**Addendum No. 1**  
**January 13, 2023**

Project: Baltic High School Addition  
Baltic, South Dakots  
Arch Project No. 2957

Architect: Architecture Incorporated

**E** SOUTH ELEVATION - AREA F  
 SCALE: 1/8" = 1'-0"

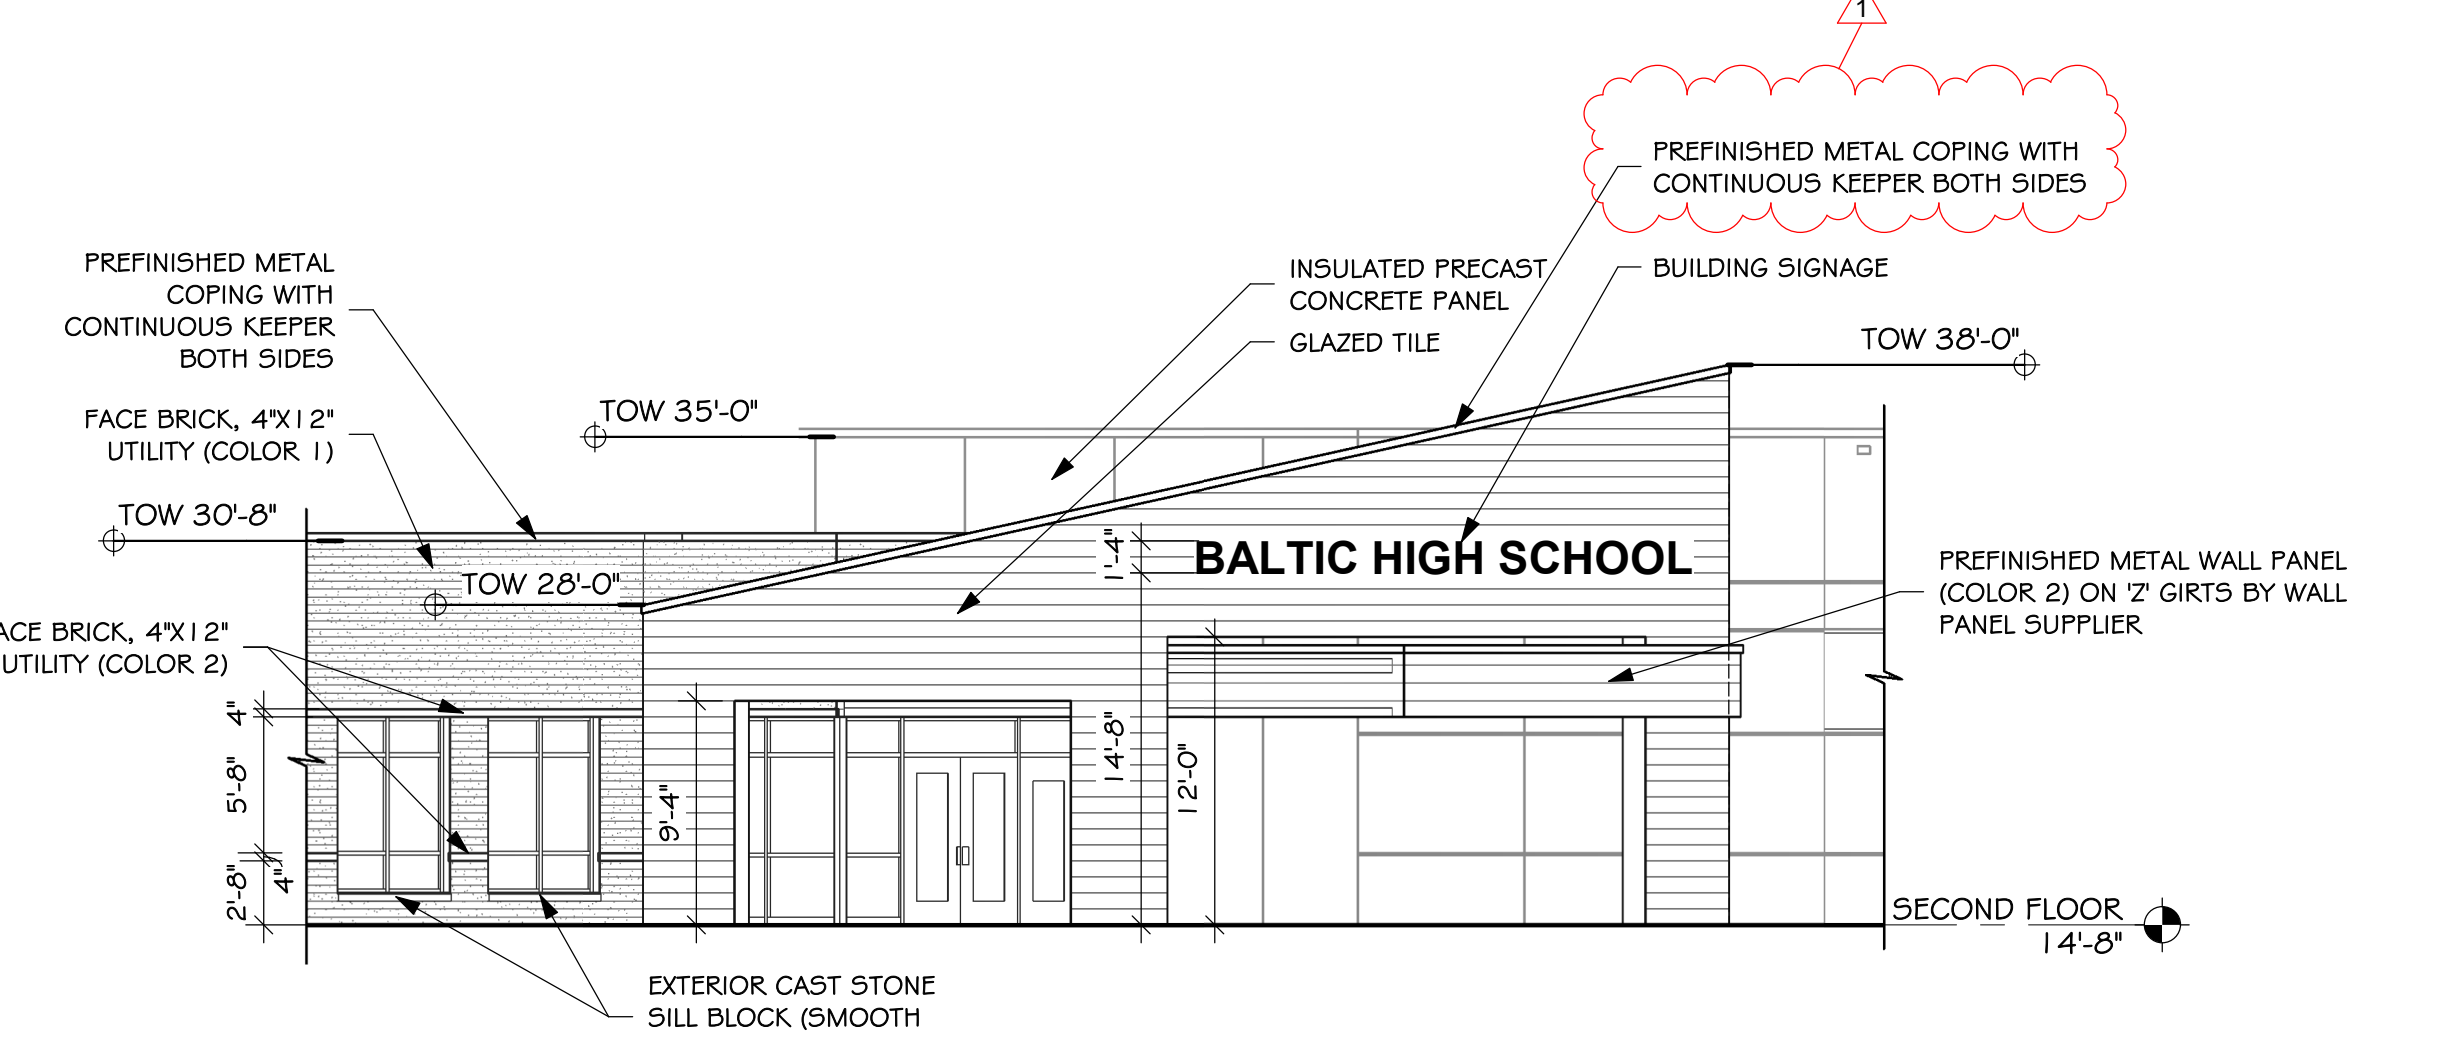
- a) Reference updated exterior elevation F/5.11 for clarifications to exterior lettering height; letters to be 16 inches high as shown.
- b) Reference updated exterior elevations D, E & F/5.11 for cast stone sill keynotes.
- c) Reference newly added brick reveal detail 5/5.11.
- d) Reference updated exterior elevations D & E/5.11 which now show brick reveal detail section callouts.

29 SILL DETAIL  
5.14 SCALE: 1 1/2" = 1'-0"

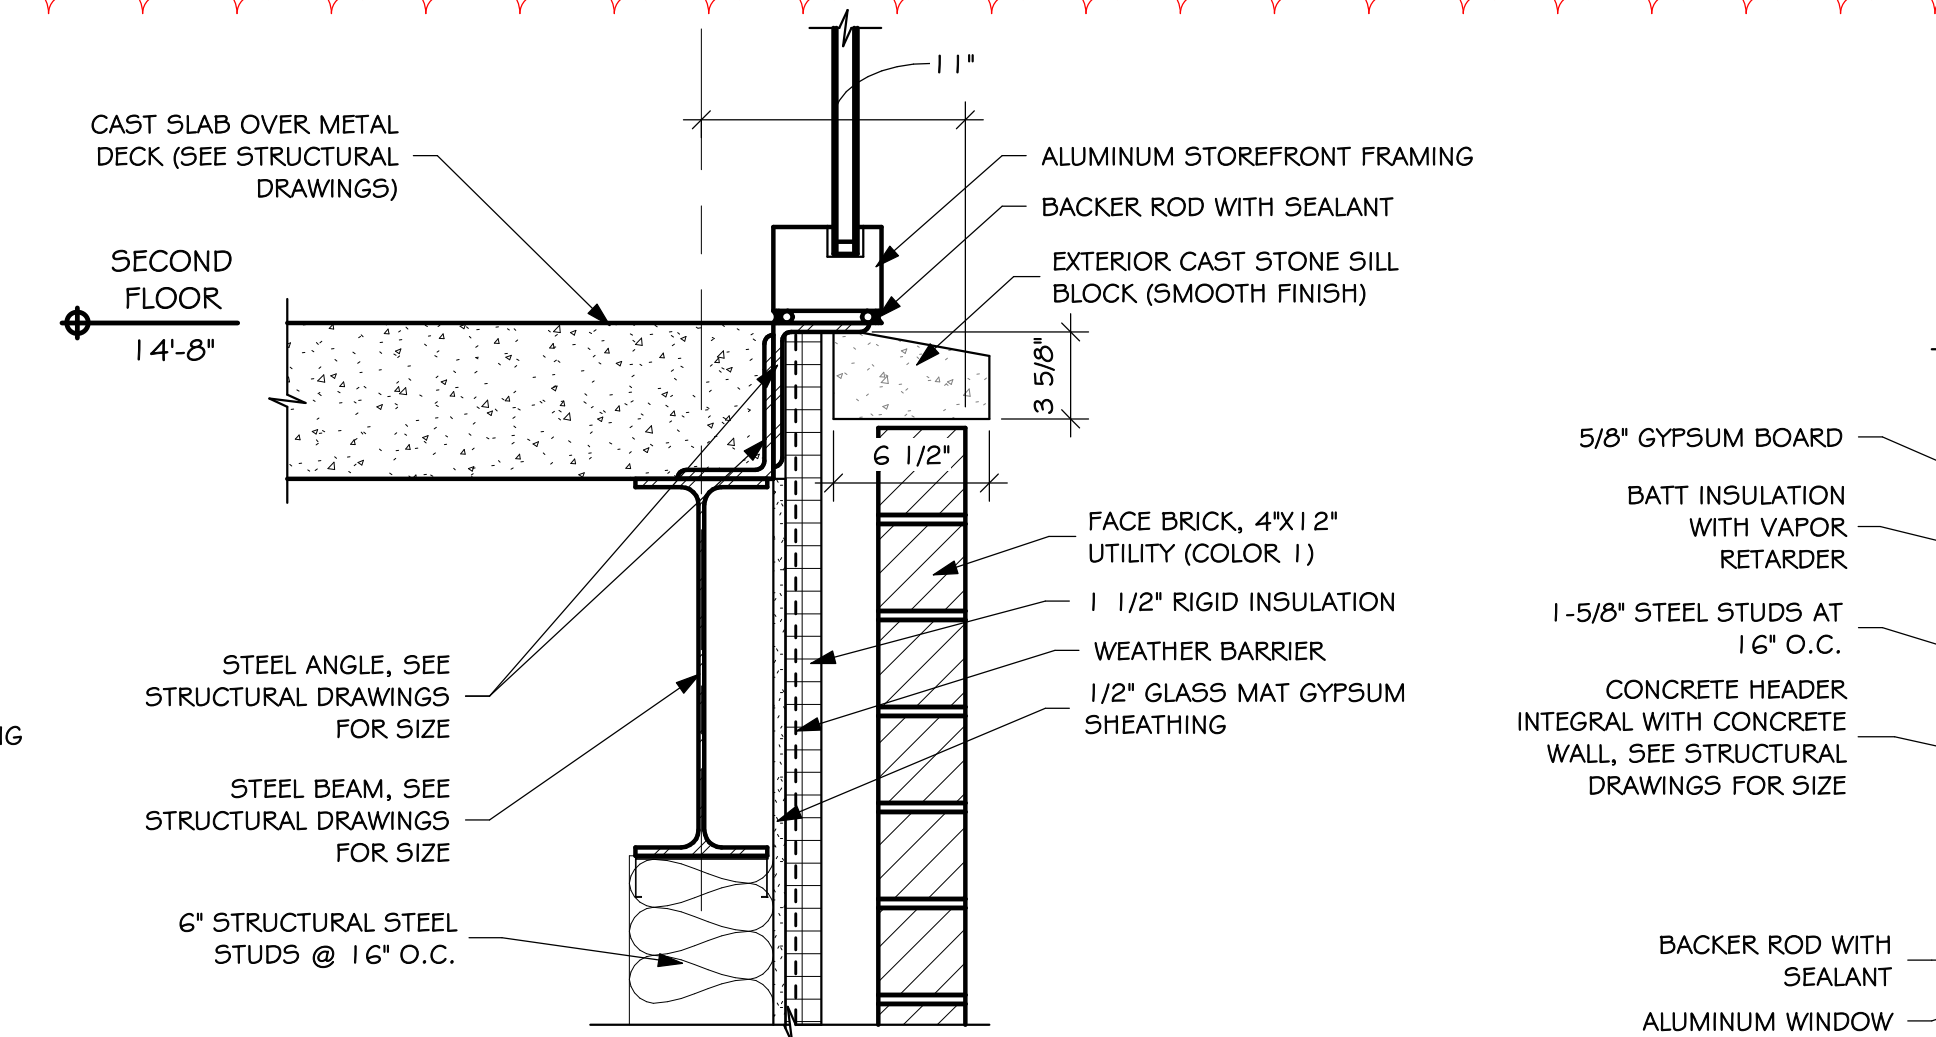
iv) Reference new details 28/5.14 – HEAD DETAIL (jamb sim.) & 29/5.14 SILL DETAIL.

**8.21**

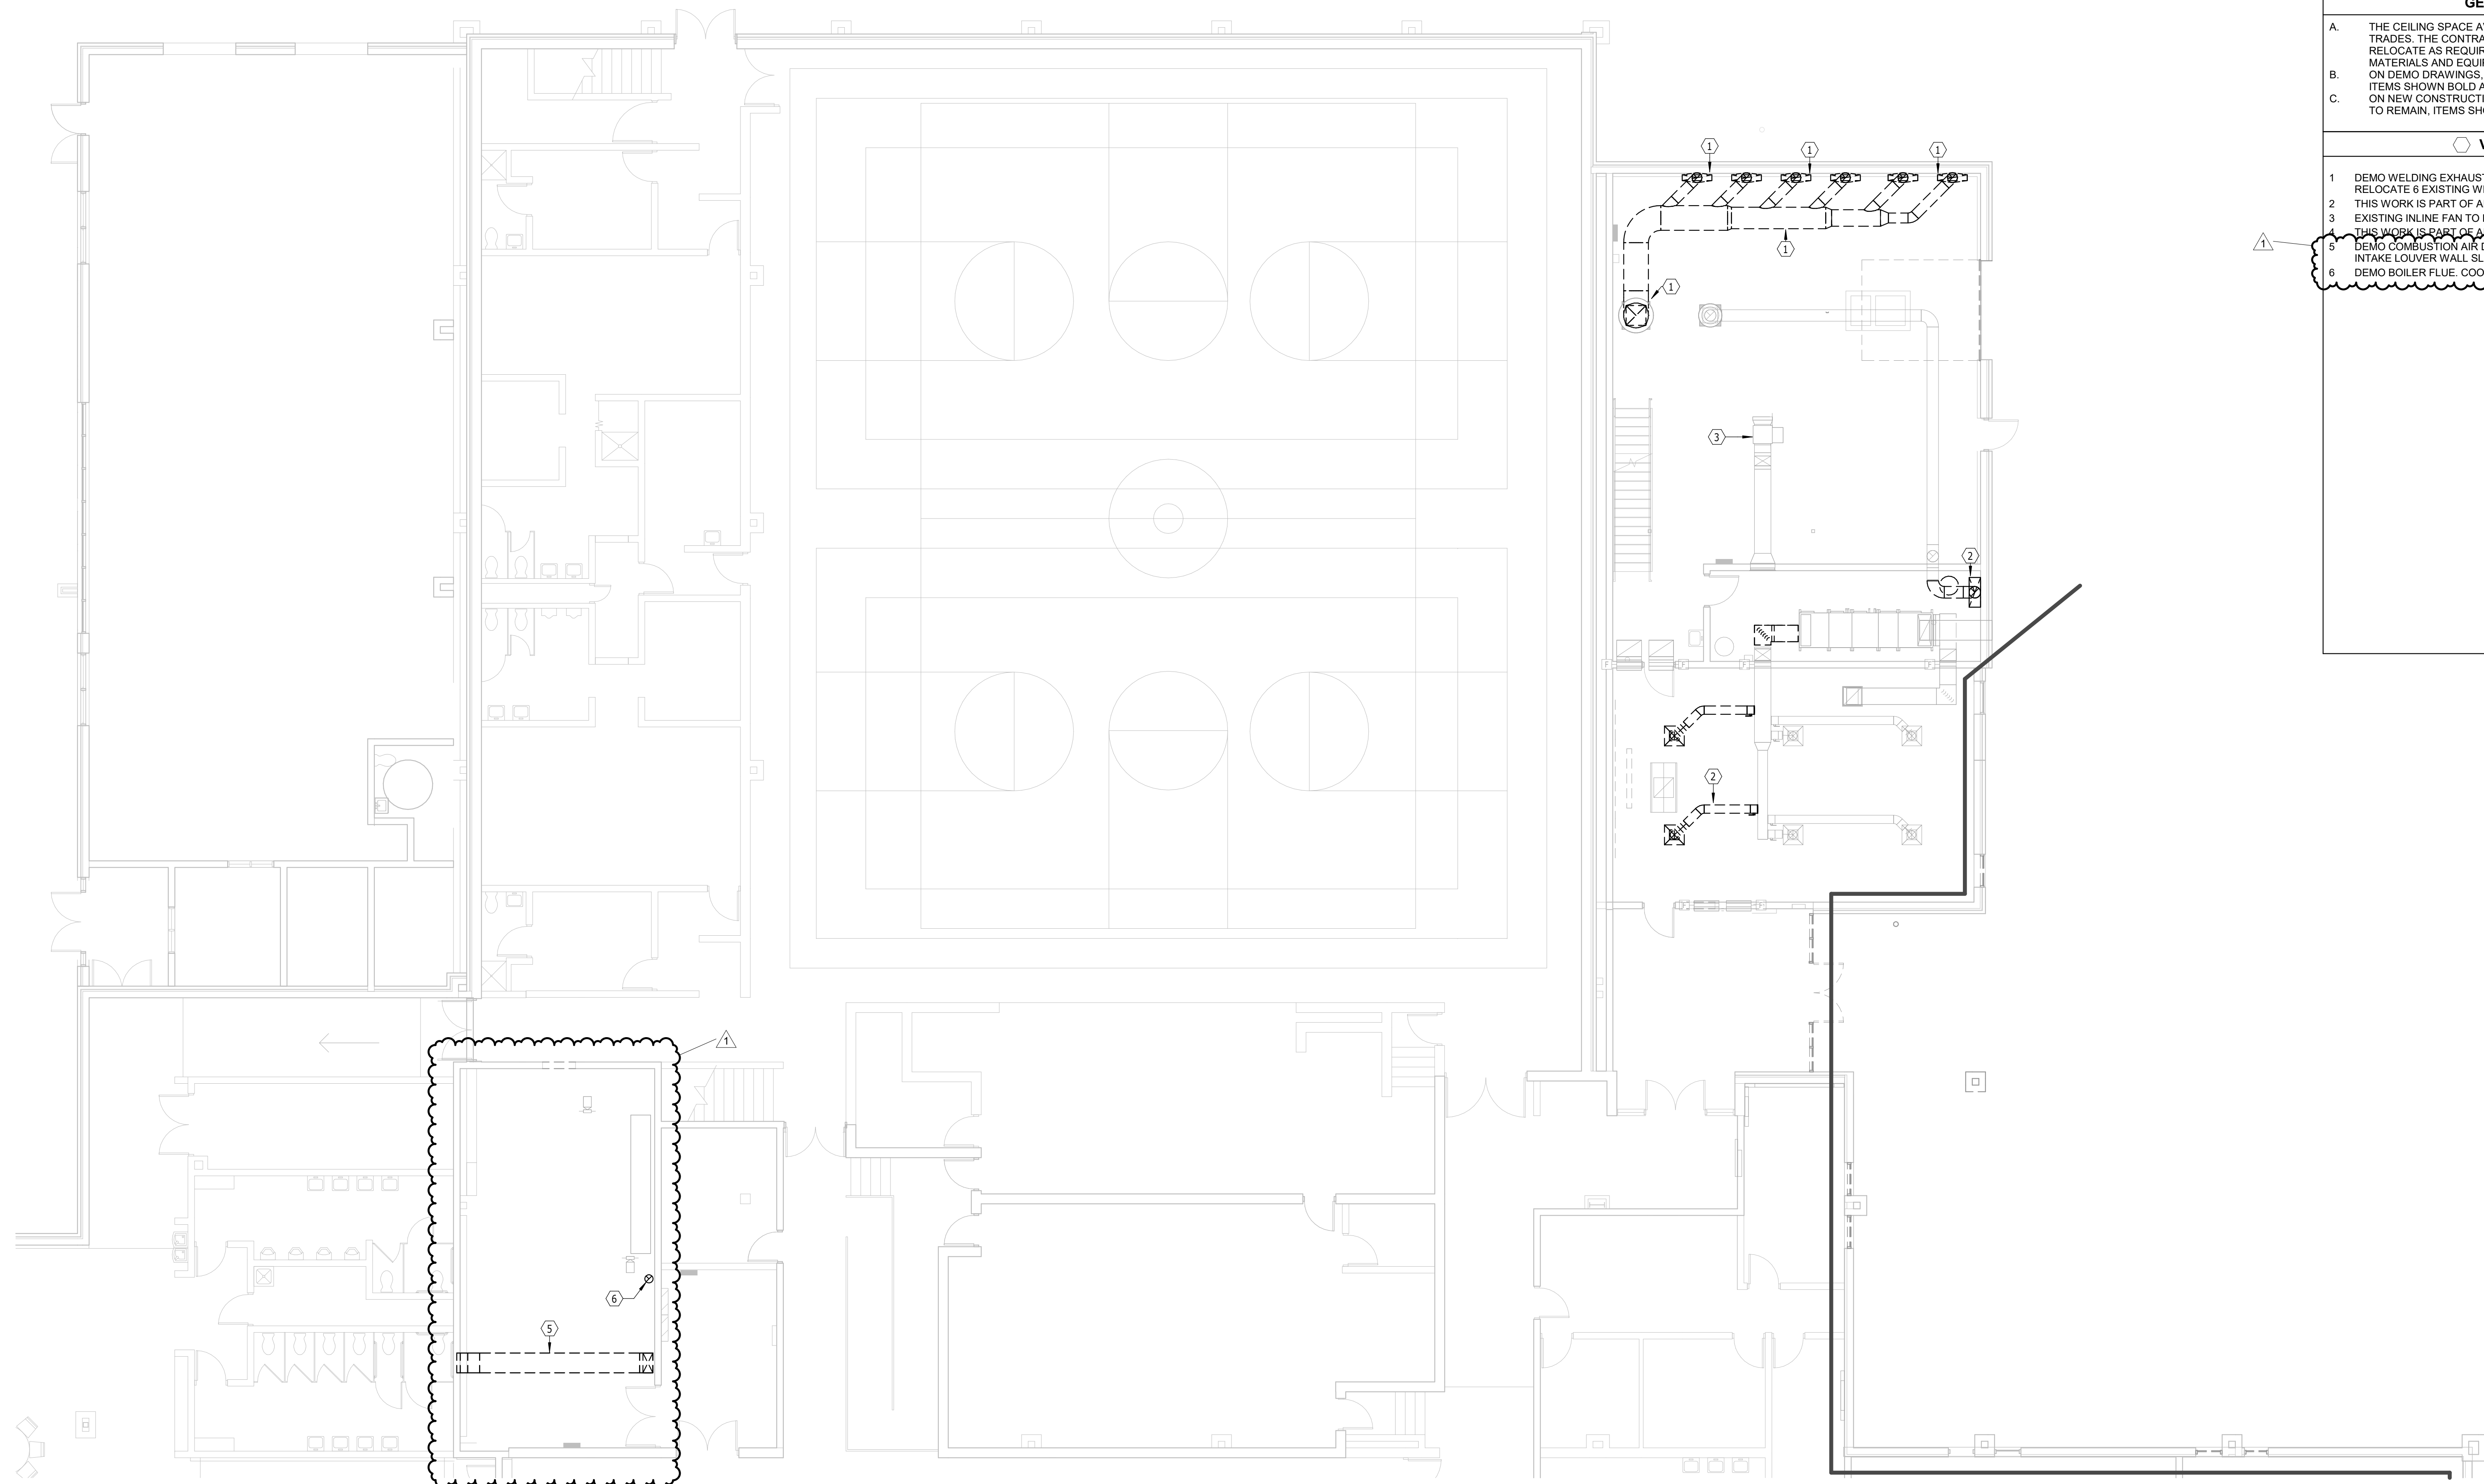
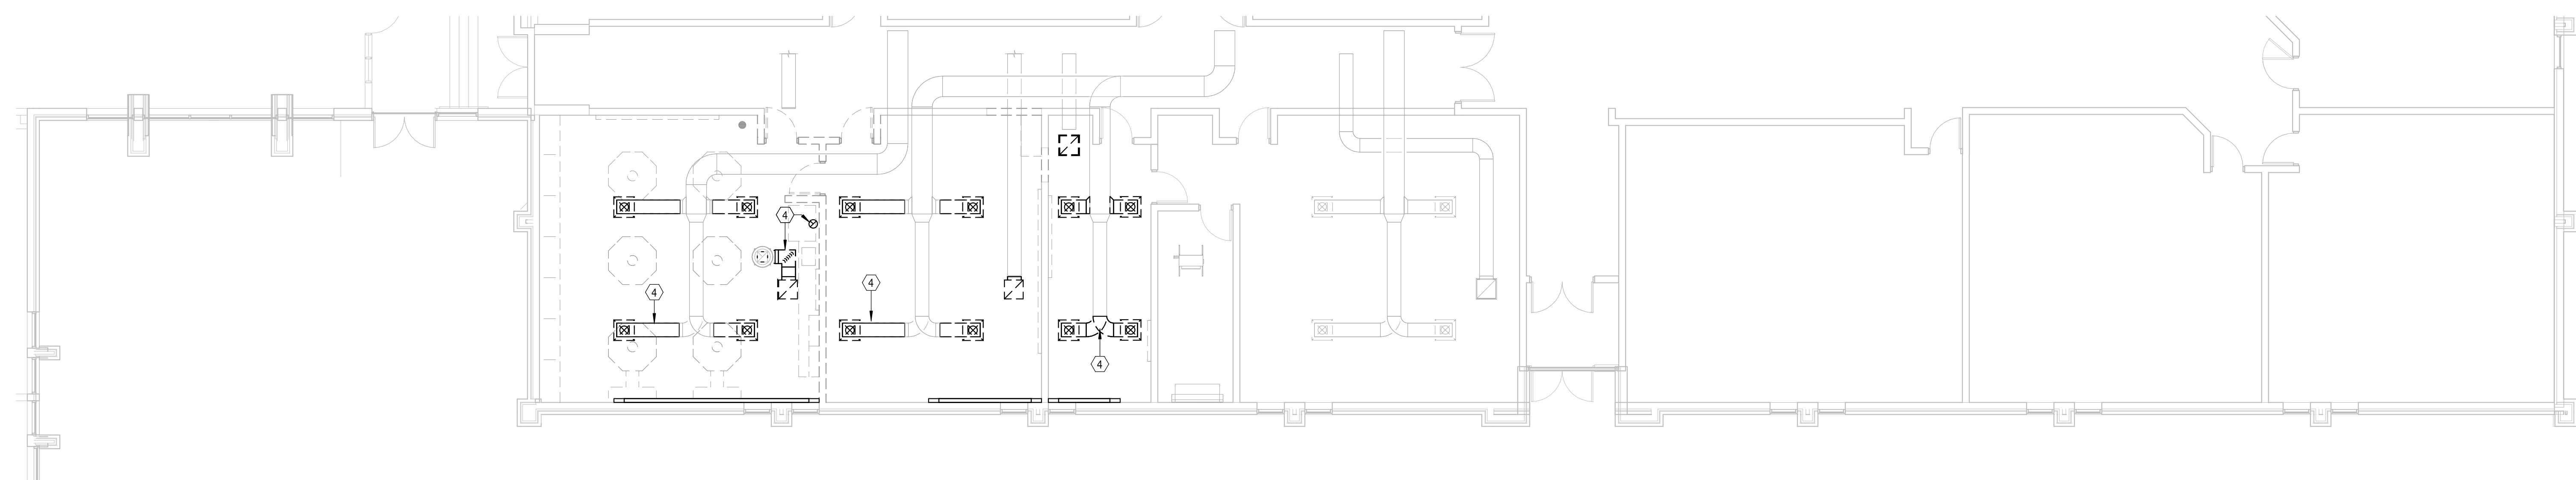
2) DRAWING SHEET 8.21 – ENLARGED MECHANICAL ROOM - AREA A – DEMOLITION – PLUMBING & HEATING

- a) Additional demolition items & detail are added. Refer to revised Drawing Sheet 8.21, Addendum 1, dated 1/13/23.
